PEARSON SUBDIVISION,
RESUBDIVISION OF LOTS 3, 4, & 5 BLOCK 4

APPLICATION NUMBER 3 DATE August 20, 2015
APPLICANT Pearson Subdivision, Resubdivision of Lots 3, 4, & 5, Block 4
REQUEST Subdivision

DETAIL SITE PLAN

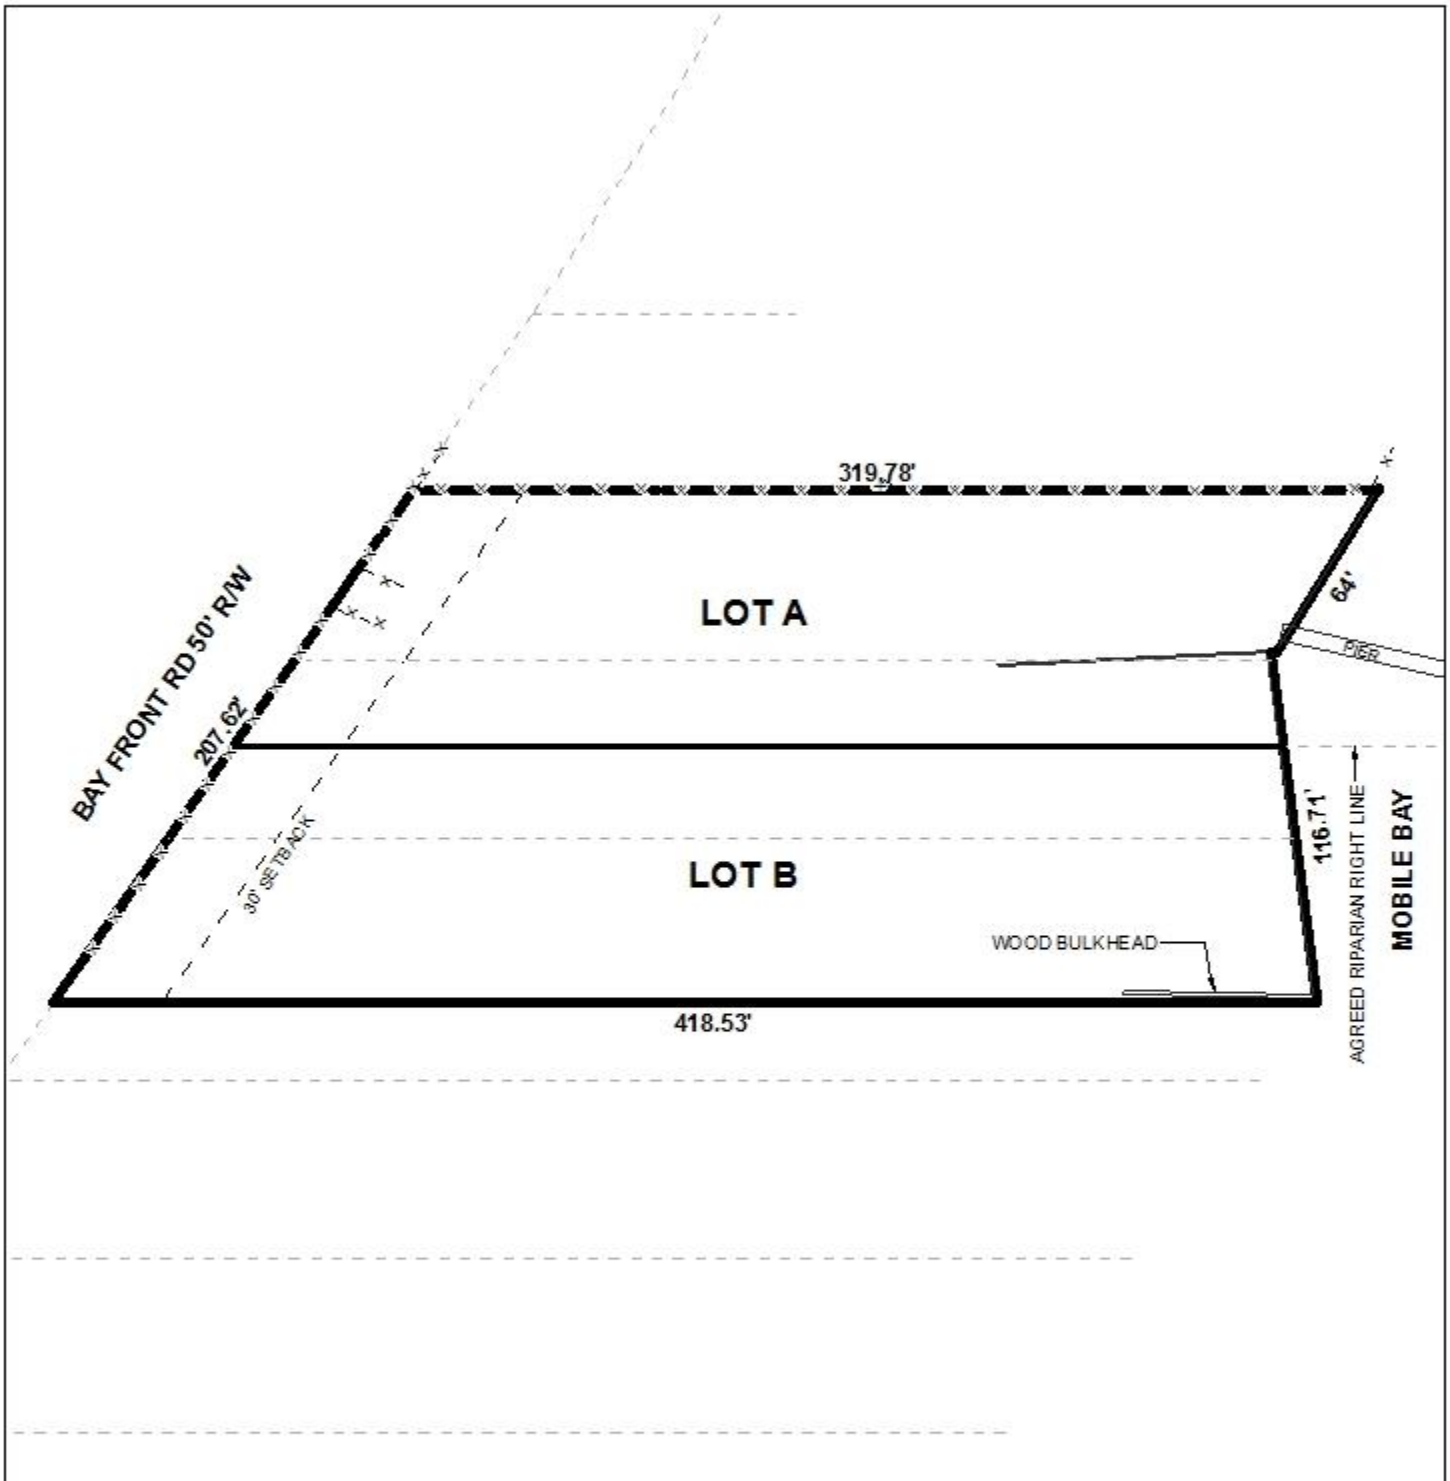
- B. Show and label the drainage ditch along the south property line of LOT B. This area is receiving drainage from a public street and must be located within an easement or public right-of-way.

- C. Show and label all flood zones.
- D. Show and label the MFFE (Minimum Finished Floor Elevation) on each lot that contains an AE, V, or X (shaded) flood zone designation.

- E. Show and label each and every Right-Of-Way and easement.
- F. Add a note to the SUBDIVISION PLAT stating that a Land Disturbance permit will be required for any land disturbing activity in accordance with Mobile City Code, Chapter 17, Storm Water Management and Flood Control); the City of Mobile, Alabama Flood Plain Management Plan (1984); and, the Rules For Erosion and Sedimentation Control and Storm Water Runoff Control.

The proposed lots front Bay Front Road, a minor street without curb and gutter. As a minor street without curb and gutter, the street requires a minimum right-of-way width of 60 feet, and is illustrated as having an existing right-of-way width of 50 feet. The Final Plat, if approved, should be revised to reflect dedication sufficient to provide 30 feet from the centerline.

According to Section V.D.3. of the Subdivision Regulations, Lots A and B exceed the maximum depth to width ratio for a standard lot located within the city. However, it should be pointed out that other properties along Mobile Bay are configured in a similar manner and have been for some time now. The current shape of the proposed lots will be keeping in character with surrounding properties along the waterfront. A waiver of Section V.D.3 will be necessary in order to accommodate the proposed width-to-depth ratio.

The preliminary plat depicts a 30-foot minimum building setback line and should be retained on the Final Plat, if approved, reflecting any required right-of-way dedication.

As a means of access management, a note should be required on the Final Plat, if approved, stating that Lots A and B are limited to one curb cut each to Bay Front Road, with the size, location and design to be approved by Traffic Engineering and conform to AASHTO standards.

The proposed lots sizes are provided in square feet and acres, and would exceed the minimum required lot size in Section V.D.2. of the Subdivision Regulations. This information should also be retained on the Final Plat, if approved, revised to reflect right-of-way dedication.

- 1) Dedication sufficient to provide 30 feet from the centerline of Bayfront Road;
- 2) Illustration of the 25 foot minimum building setback along Bay Front Road for each lot reflecting right-of-way dedication;

- 3) Placement of a note on the Final Plat, stating that Lots A and B are limited to one curb cut each to Bay Front Road, with the size, location and design to be approved by Traffic Engineering and conform to AASHTO standards;

- 4) Retention of the lot sizes in square feet and acres on the Final Plat, revised for right-of-way dedication;
- 5) Compliance with Engineering comments (*The following comments should be addressed prior to submitting the FINAL PLAT for acceptance and signature by the City Engineer:*
